**McCARTY COMMONS  
INTERSTATE HIGHWAY 35/McCARTY LANE SEC  
PLANNED DEVELOPMENT (PD) DISTRICT  
DEVELOPMENT STANDARDS**

**Amended and Restated INSERT DATE ~~May 21, 2013~~**

**Note on 2026 amendment – the proposed changes to this document have been requested by HEB, LP, who now own part of the property within the District Boundary.**

11 McCARTY COMMONS / SIGNAGE LINEUP  
SCALE: 1/8" = 1'-0"

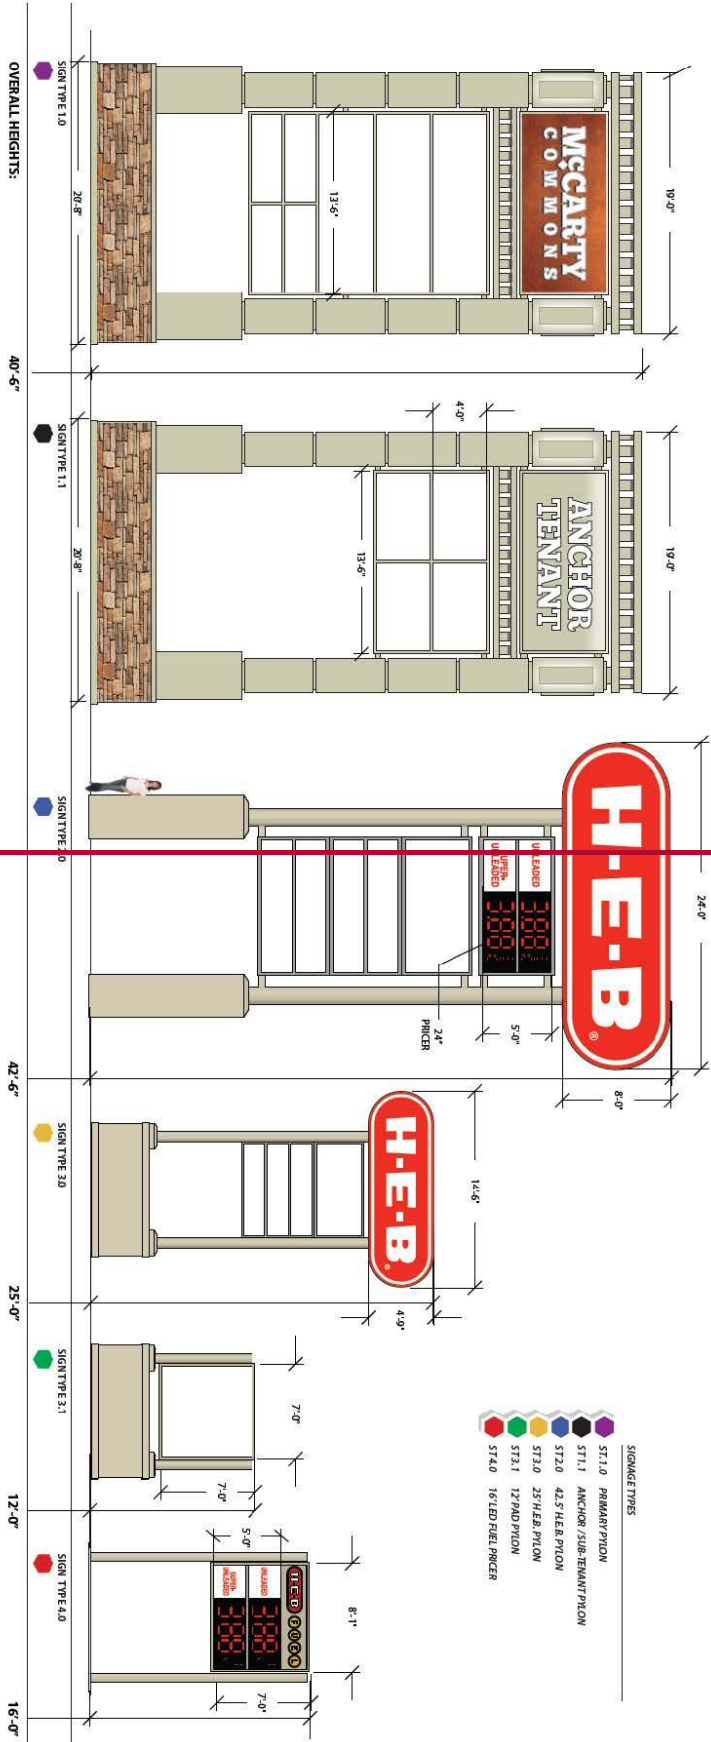
Staff Note: This page removed

# Staff Note: New page added
